The LArSoft architecture (draft)

535 **Comments**

2016/02/11, 16:36, David Adams dladams@bnl.gov (“Re: LArSoft architecture document draft”)

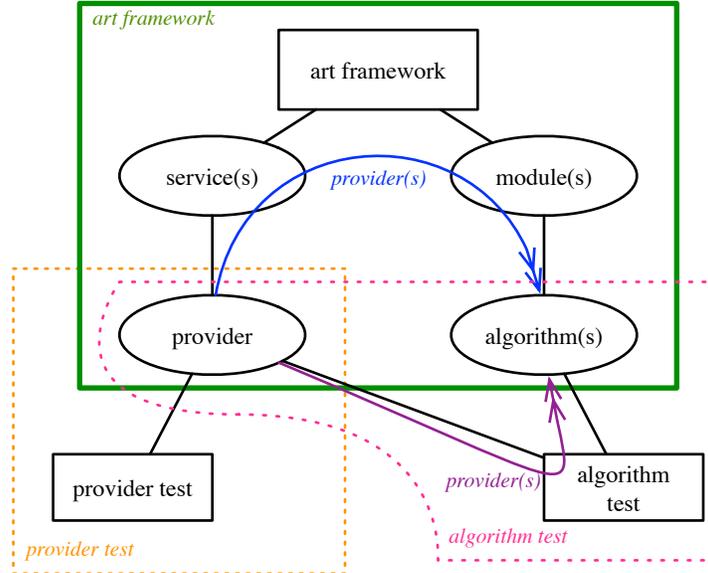
[Q 0201] 1. Could you please clarify how algorithms instantiate their providers? This is the blue line in fig. 10.

540 [A 0201.1] [GP] I have added text in section 5.4:

The typical implementation of this pattern in the *art* framework is the following: the module, when setting up the algorithm (possibly on each event), obtains the services it needs from the framework, obtains the provider from each of these services, and uses the algorithm interface to propagate these providers to the algorithm itself.
